Alexandria Toyota
3750 Jefferson Davis Highway

Text Amendment #2008-0006 (A)

DSUP Amendment #2007-0034 (B)

Planning Commission
June 3, 2008

Figure 5 Building South Elevation

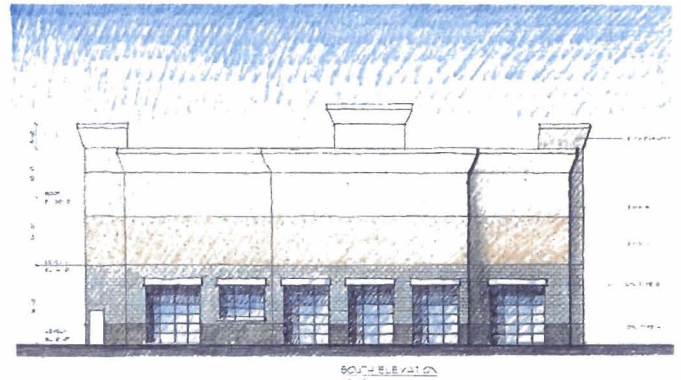
4. **Condition added by staff:** The proposed building shall be consistent with the building elevations dated April 25, 2208 and shall provide the following to the satisfaction of the Director of P&Z.
 - a. The car detailing building shall be of similar style and materials as the main dealership building.

Figure 7 Staff Recommended Landscape Along Commonwealth Avenue

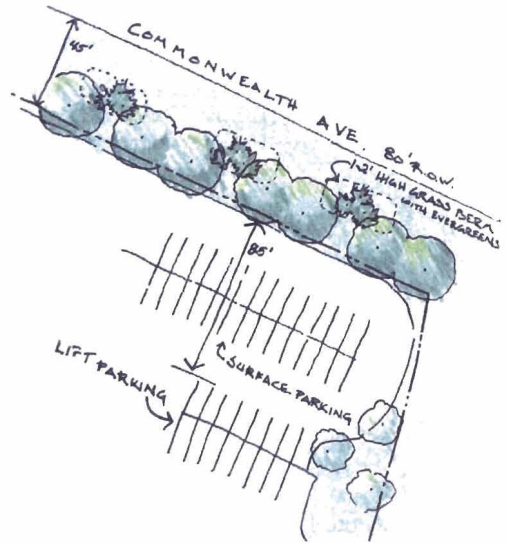
6. **Condition amended by PC:** The applicant shall provide a landscape design along the entire Commonwealth frontage as generally depicted in Attachment #1 and shall be designed and installed and to the satisfaction of the Directors of P&Z and RP&CA. The plan shall include:

- c. The design shall include an 8 foot decorative wooden fence; fence design and material subject to review and approval.
 - d. The design shall be installed and approved, except for the trees, prior to the any vehicular parking within the RC zone district. The trees shall be installed prior to release of the final site plan. (P&Z)
